B. Objection To The Drawings

Title: Fabric For Use In The Manufacture Of Tissue Products
Having Visually Discernable Background Texture Regions
Sordered By Curvilinear Decorative Elements & Method Thereof
Inventors: M.A. Burazin et al.

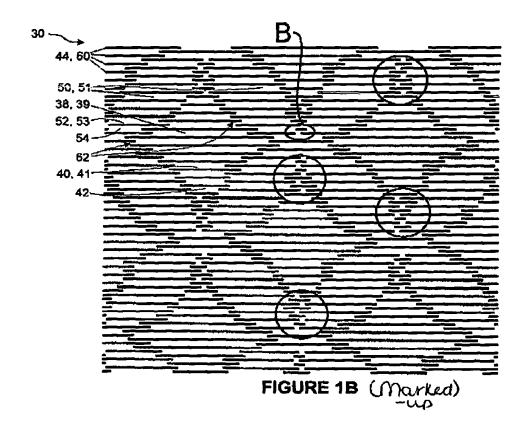
In the marked-up figure of Figure 1B, Applicants point out a similar event shown in the vertexes of the transition regions forming diamond-like patterns. Four large circles have been drawn around these vertex regions, and a smaller ellipse labeled as "B" has also been drawn around one of these vertex regions. In each of these regions, there are a series of features similar to that of Figure 8, with floats momentarily sinking beneath a single shute, adjacent to sinkers that momentarily rising next to the place where the floats descend. A difference relative to Figure 8 is that when the elevated warps (such as floats) descend under a single shute, the adjacent warps serving as sinkers rise to pass over two or three shutes instead of a single shute as in Figure 8. However, Claim 31 and 111 does not require that the transition region extend for only a single shute.

FIGURE 9 (Marked-up)

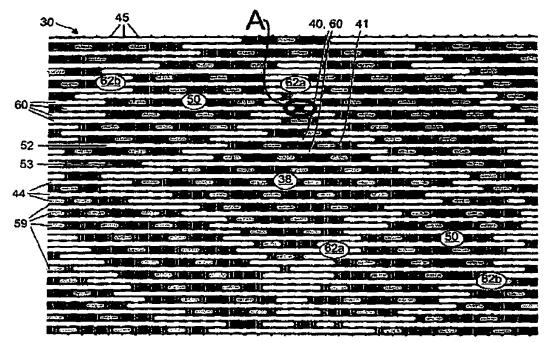
The drawings were objected to because Figure 9 failed to show the contrast between the while floats and the gray intermediate knuckles and shutes as described in the specification on page 27. Applicants submit that the objection to the drawings should be withdrawn because the original Figure 9 clearly shows the contrast between the while floats and the gray intermediate knuckles and shutes.

Applicants point to other figures as further supporting the Claims 31 - 61 and 111 - 159 such that one skilled in the art would readily understand the woven structure. Applicants' have attached marked-up figures (Figures 1B and 9). The marked-up figure of Figure 9 shows an ellipse labeled "A" around a region of the fabric where a warp serving as a float passes beneath a single shute and then rises again to become a float, as does warp 44a in Figure 8. When the warp passes beneath a single strand, the adjacent warps are serving as floats, similarly as shown in Figure 8 (though the adjacent warp 44b in Figure 8 passes over a single shute at that point). Applicants point out that in the circled regions, significant portions of the transition regions correspond to Claims 31 and 111, with warps that are floats to the left of the transition region becoming floats again to the right of the transition region. These floats are next to sinkers that become slnkers again after passing through the transition region.

Marked-Up Figures 8, 15 & 17

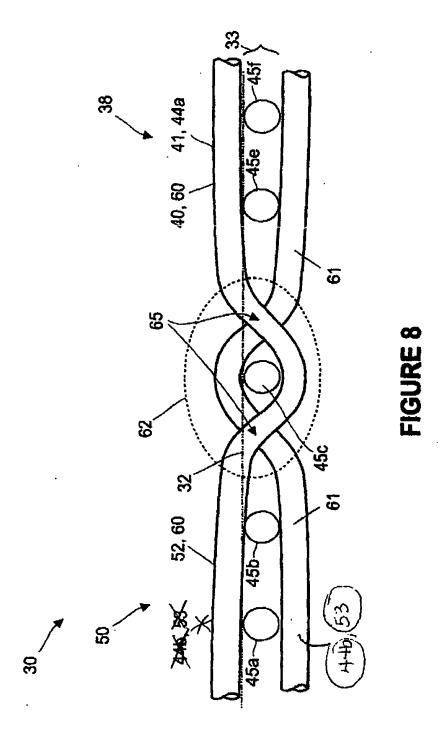
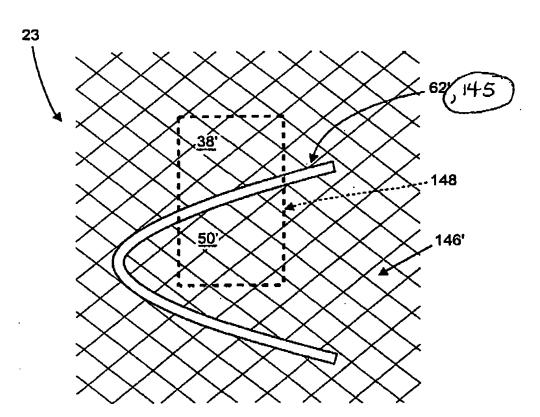
The drawings were objected to as failing to comply with 37 CFR 1.84(p)(5) because they do not include the following reference signs mentioned in the description:

The drawings were objected to as failing to comply with 37 CFR 1.84(p)(4) because reference characters "44a" and "44b" have both been used to designate the same upper warp in Figure 8. Applicants submit that the objection to the drawings should be withdrawn because Figure 8 has been corrected to show the proper location of "44b" as supported in the specification at page 20, line 31 to page 26, line 11. A circle-marked copy of Figure 8 has been attached to this response.

Applicants submit that the objection to the drawings should be withdrawn because Figure 15 has been amended to show the primary pattern 145 with the elevated transition region 62" as supported in the specification at page 43, line 29 to page 44, line 9 and Figures 17 has been amended to show the absorbent tissue product 27 as supported in the specification at page 12, line 19 to page 15, line 2. Circle-marked copies of the Figures 15 and 17 have been attached to this response.

New Figures 8, 15 & 17 Incorporating Changes Made

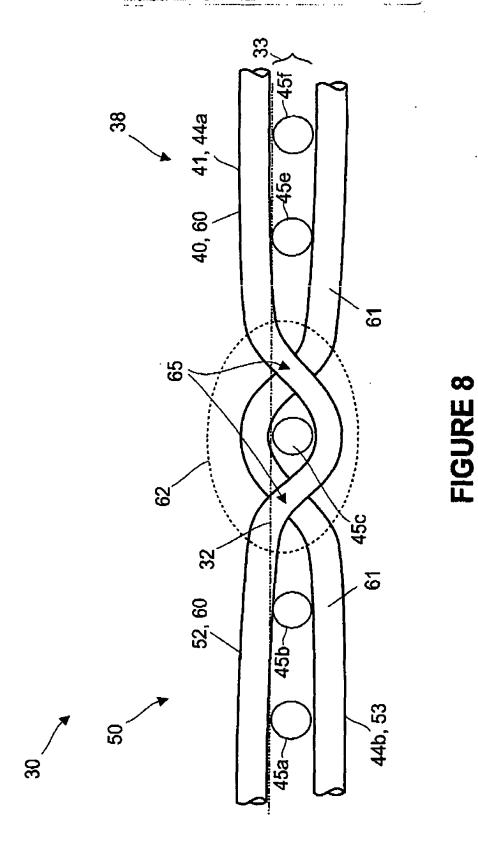
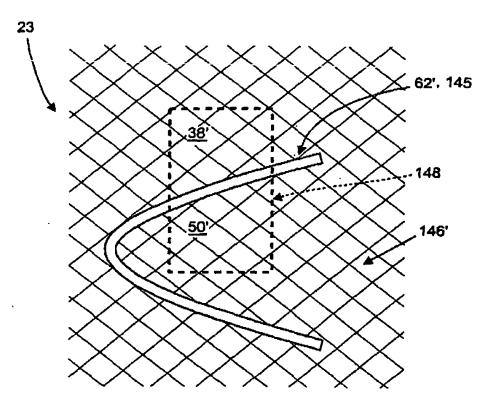
27 - absorbent tissue product

145 - primary pattern

64 - circular primary pattern.
